Product Change Notification

Change Notification #: 111931 - 00
Change Title: Intel® SSD 310 Series (40GB, 80GB)
PCN 111931-00, Label
Add Intel URL to SSD Label
Date of Publication: December 14, 2012

Label

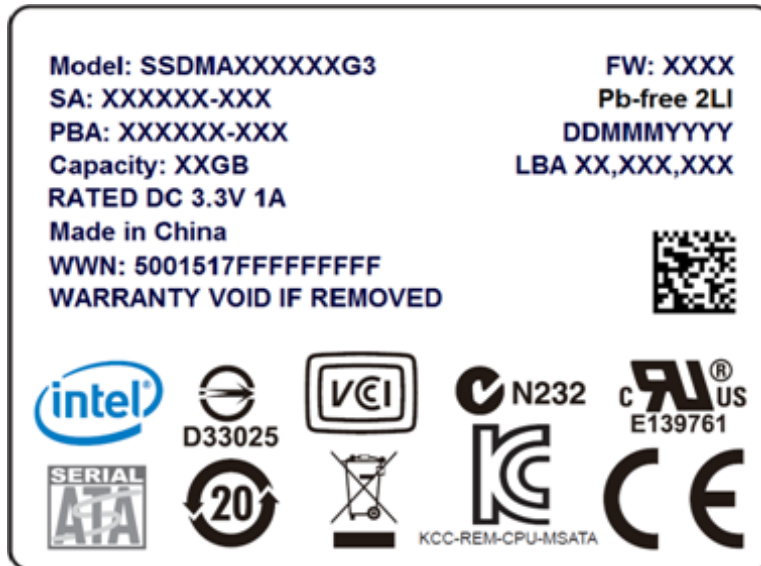
To meet EU regulatory requirements, Intel will be adding the Intel URL to the SSD label.
See images below:
